Memorandum

To: Wendy Farley-Campbell
From: Mike Miller
Date: January 7, 2025
Re: PC 24 39 DR 13 – NW 9th Street Neighborhood Project

Project Proposal – NW 9th Street Neighborhood Project

Map 2-4 from the December 2012 Florence Transportation System Plan is shown below:

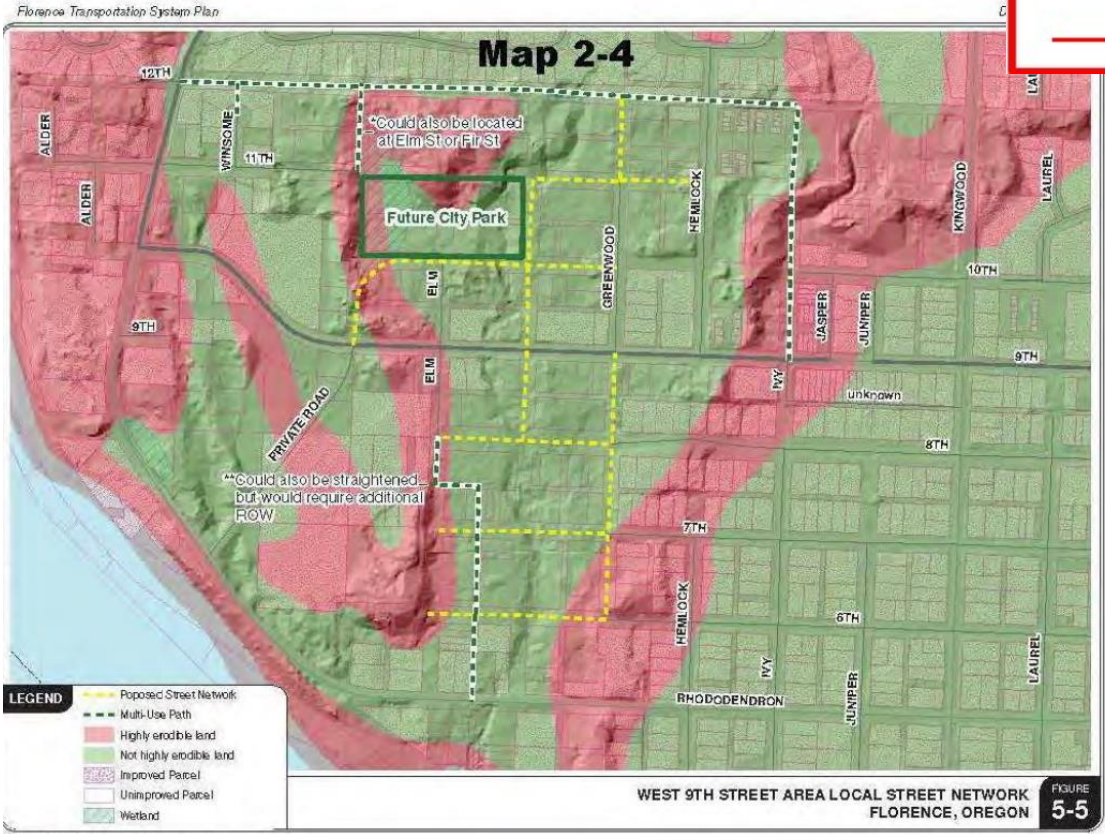
In reviewing the Florence Comprehensive Plan, we believe that the Comprehensive Plan limits of Subarea 2 should not be expanded outside of Subarea 2. Subarea 2 restrictions do not impact the proposed project. We do acknowledge that Fir Street north of 11th Street could fall within the Comprehensive Plan Subarea 2, and we have eliminated that portion from our project. Additionally, the Comprehensive Plan diagram (Map 2-4) does not show Fir Street extending north of 11th Street.

Wetland/Riparian Area Exhibit

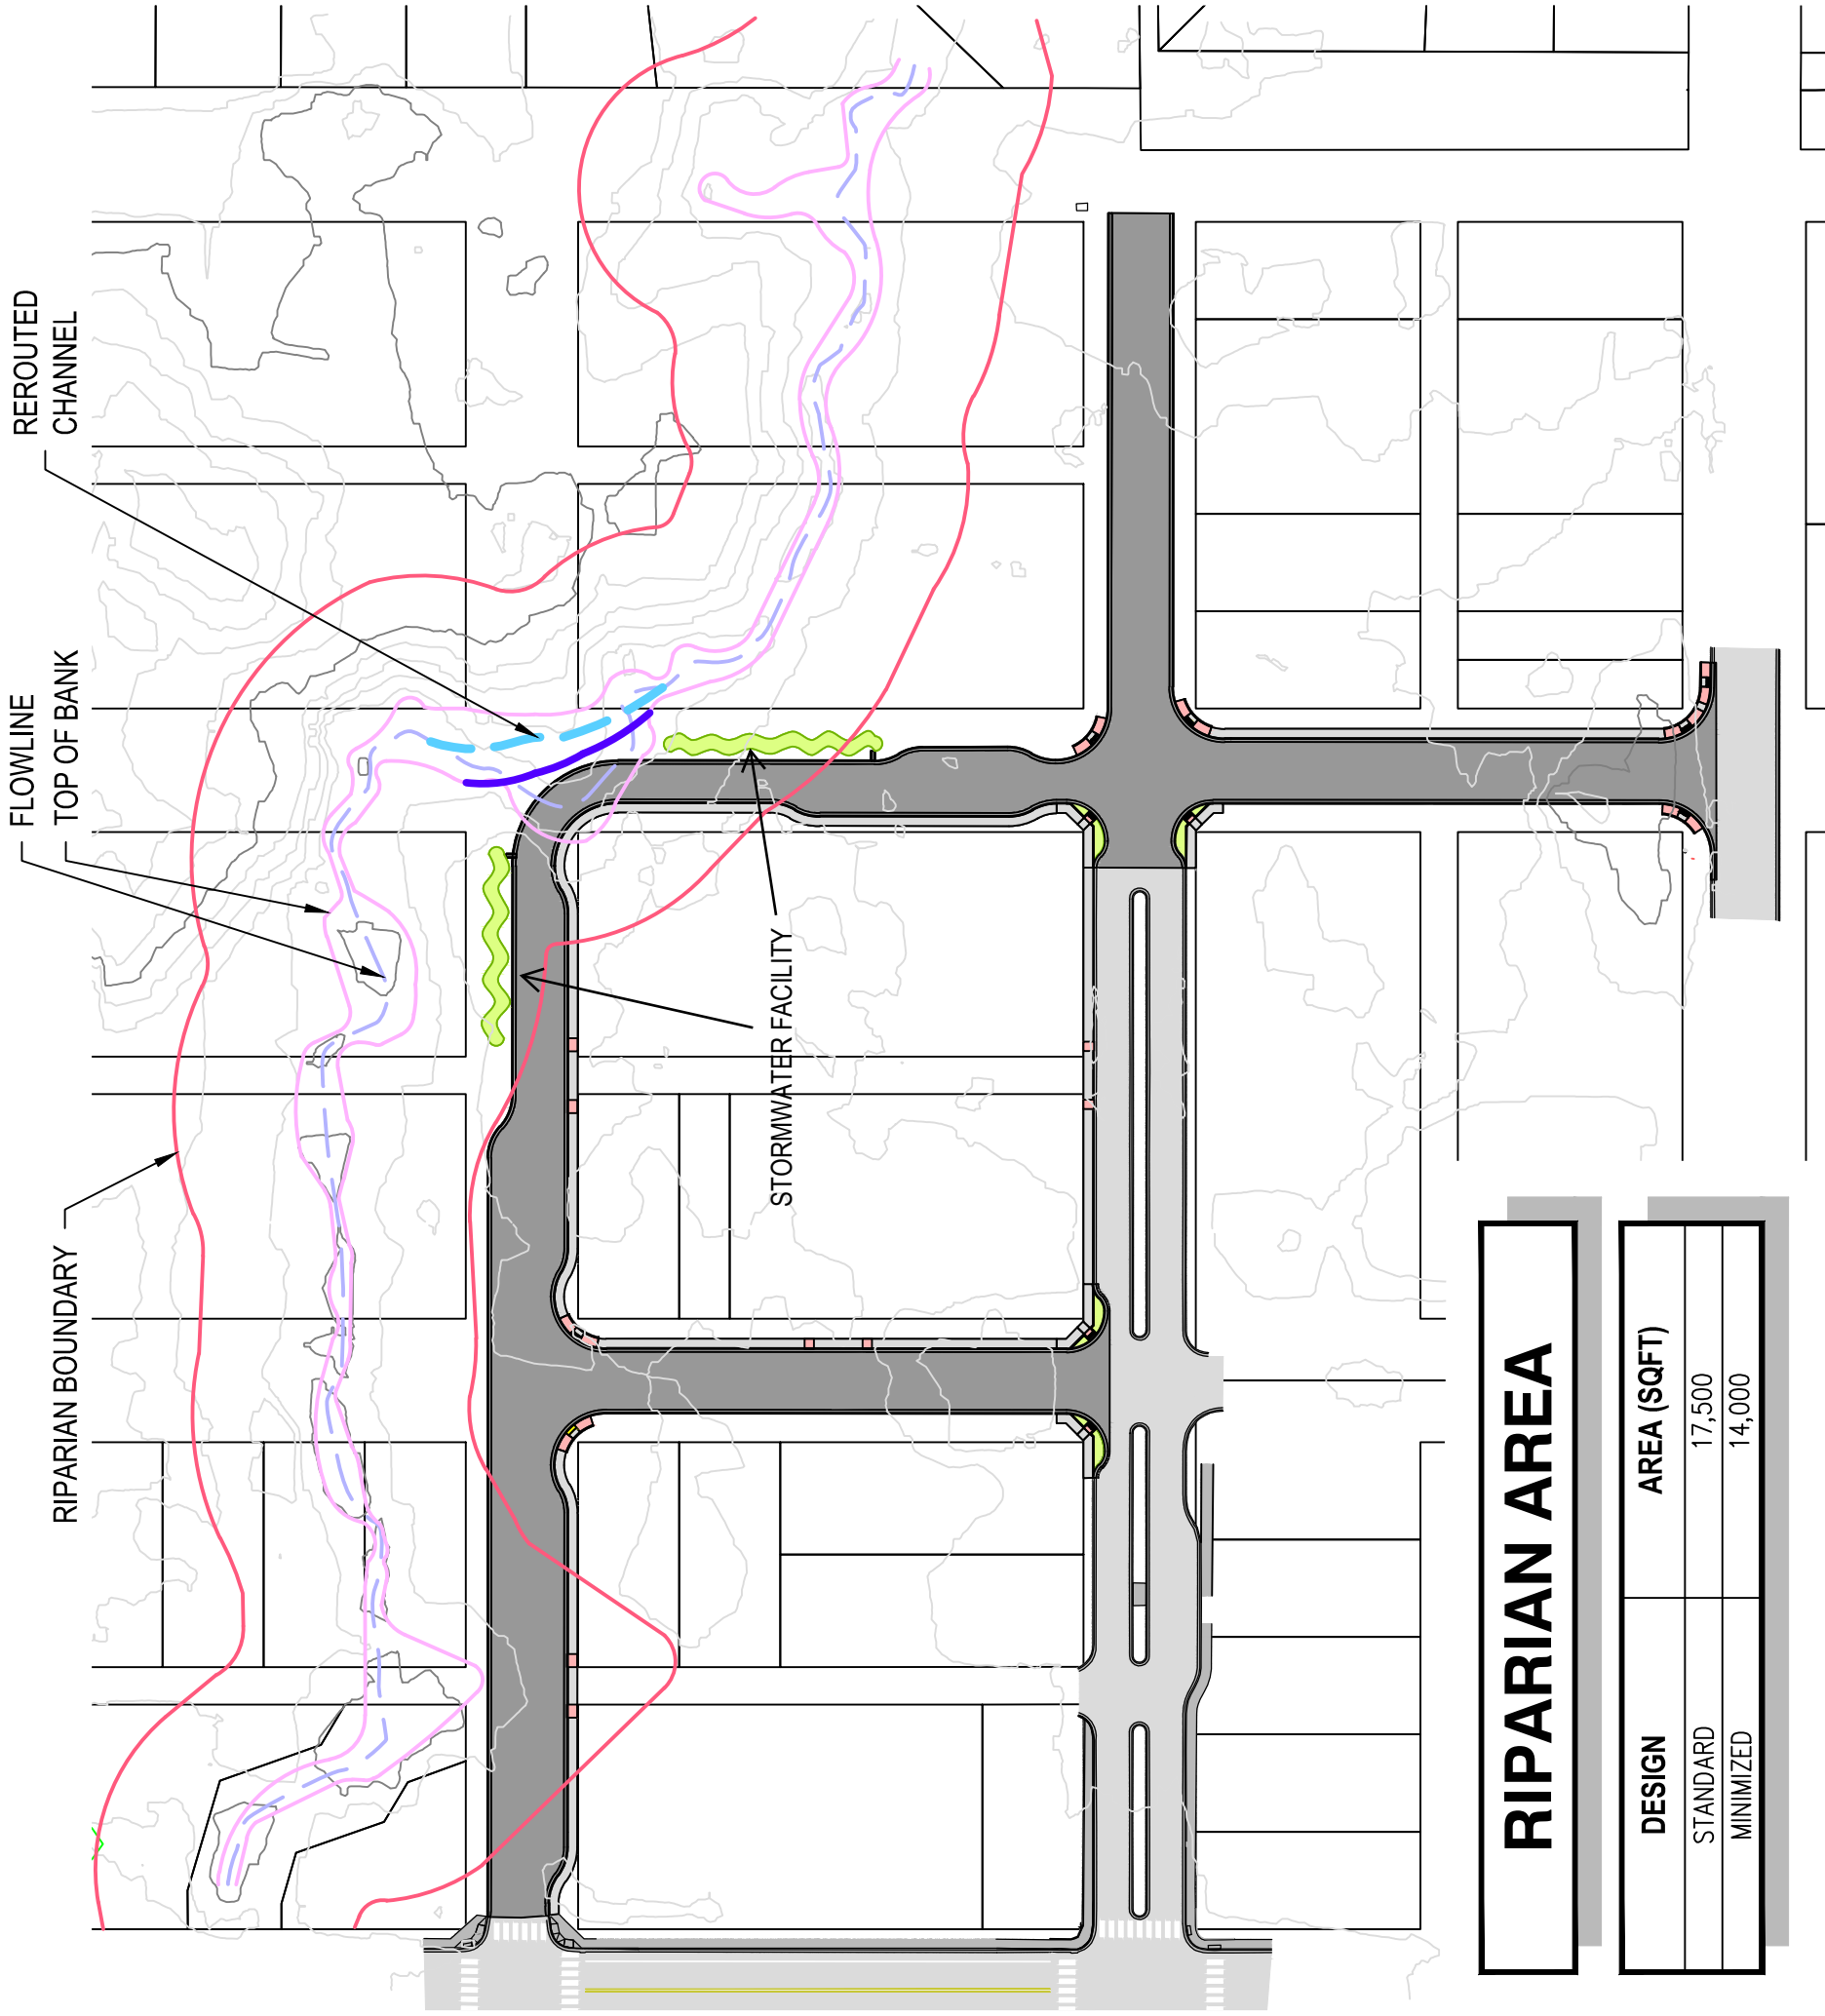
With this new information, we have been working with our engineering team to minimize intrusion into the riparian buffer area. These measures include reducing the standard street cross section from the standard of two 10-foot travel lanes; two 7-foot parking lanes; and two 5’ foot

wide sidewalks (5.5 feet including curb) to a minimized cross section with only two 11-foot travel lanes and sidewalk on the south or east side of the street (Fir Street would be east side and 11th Street would be south side). We also show an area along Fir Street with a minimized street cross section that included one 7-foot parking lane and two 11-foot travel lanes. With the potential development of the City park, Elm Park, west of Fir Street, we are showing parking on both sides of Fir Street from 9th and to the alley between 10th and 11th streets, The standard street cross section would equal 17,500 square feet, however using these minimized street cross sections, we are able to reduce the impervious area to 14,000 square feet which is a 20-percent reduction.

We have also shifted the roadway along Fir Street right-of-way to the east with the back of sidewalk at the property line and curb extension or curb bulb outs at the intersection corner to avoid the sidewalks from encroaching upon private property. The design also calls for the elimination of the sidewalk on the north side of 11th Street between Greenwood and Fir streets. The sidewalk along the west side of Fir Street between 9th and 11th streets would also be eliminated. Stormwater facilities (swales or raingardens) will be incorporated along 11th and Fir streets.

Another change, since Fir Street will not extend past the north boundary of 11th Street right-of-way, there is no need to install a box culvert or arched pipe. The project will have a minimal impact to the seasonal stream channel.

The attached Wetland/Riparian Area Exhibit drawing illustrates the flowline of the seasonal stream, top of bank and riparian buffer boundary with survey accuracy in relationship to property lines. The drawing, as an exhibit illustrates the possible location of stormwater facilities, however more engineering work is necessary to fully develop the total construction level plans and approach to stormwater management. The exhibit further illustrates how we are minimizing our impacts to the riparian buffer area by shifting the roadway to the east side of Fir Street and 11th Street to the south right-of-way line. We are providing curb extension/bulb outs so as not to encroach upon private property for ADA ramps and sidewalks. With the end goal of balancing life safety; traffic and pedestrian circulation and flow; and still allowing on street parking where possible, we are able to provide residents and visitors access to the future City park on the west side of Fir Street.
